# TECHNICAL BULLETIN

**MODEL/DERIVATIVE:**  
Range Rover

**Bulletin :** 0012  
**CDS ref:** 10483bu  
**Issue:** 1  
**Date:** 02.06.99

**PROBLEM:**  
**ELECTRONIC AIR SUSPENSION (EAS) NOISE - COMPRESSOR MOUNTS**

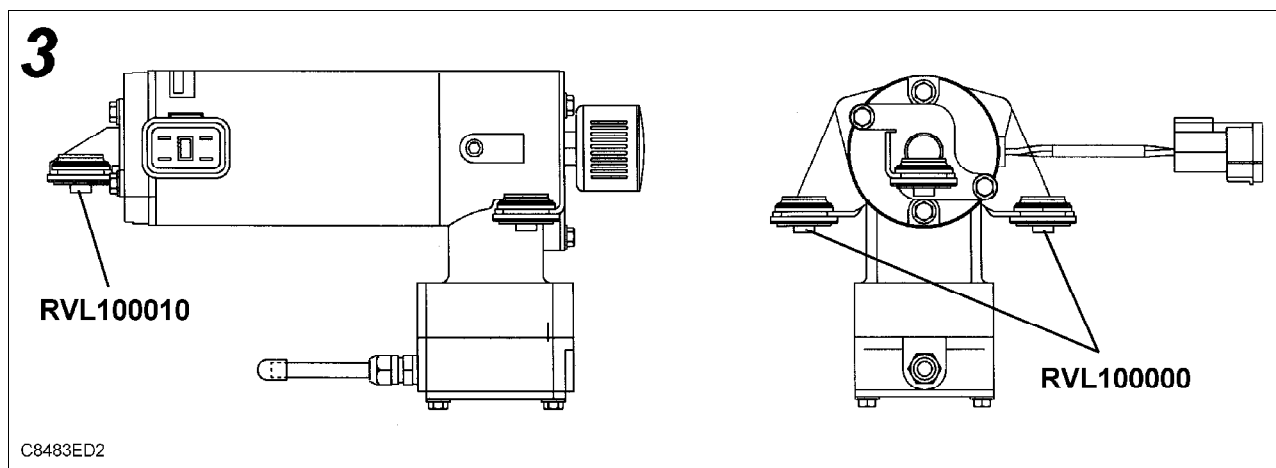
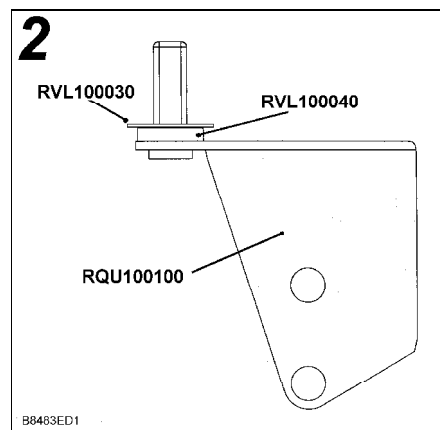
Reports of a droning noise transmitted into vehicle. The noise is apparent in the region of the front left hand corner of the vehicle and on investigation is found to originate from the air supply unit ( illustration 1 ).

**CAUSE:**  
Deterioration of the EAS compressor rubber mounts.

**ACTION:**  
Modified compressor mounts have been fitted to all vehicles from VIN XA 420550 onwards. These latest mounts can be fitted to earlier vehicles by following the procedure below:

1. Remove the EAS compressor, Workshop Manual repair number 60.50.10 refers. Retain for reuse the 3 mounting nuts and dished washers, noting their original fitted orientation, ( see illustration 4 ).

3. Referring to illustration 2, fit nylon spacer RVL100040 to bracket stud then fit flat washer RVL100030 on top of nylon spacer.
4. Remove the 2 lower front dished washers from their location in the distribution box and replace with new flat washers RVL100030.
5. Push out the 3 old mounts from the compressor assembly. Replace the 2 front mounts with new parts RVL100000 and the single rear mount with RVL100010, ensure they are fitted in the correct orientation (see illustration 3).

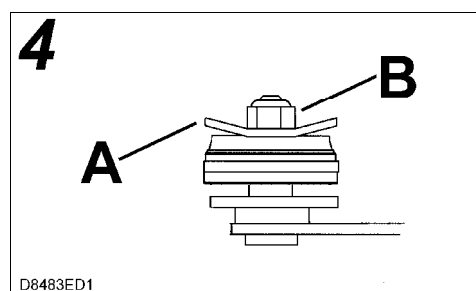
6. Refit the compressor as described in the Workshop Manual, repair number 60.50.10, ensuring that the compressor mounts are located centrally on the studs. Referring to illustration 4, refit the original dished washers 'A' and nuts 'B' to each mount, ensuring orientation is as shown. Tighten fixing nuts to 2 Nm maximum. **IMPORTANT** - do not over-tighten fixings since this will damage the new mounts.
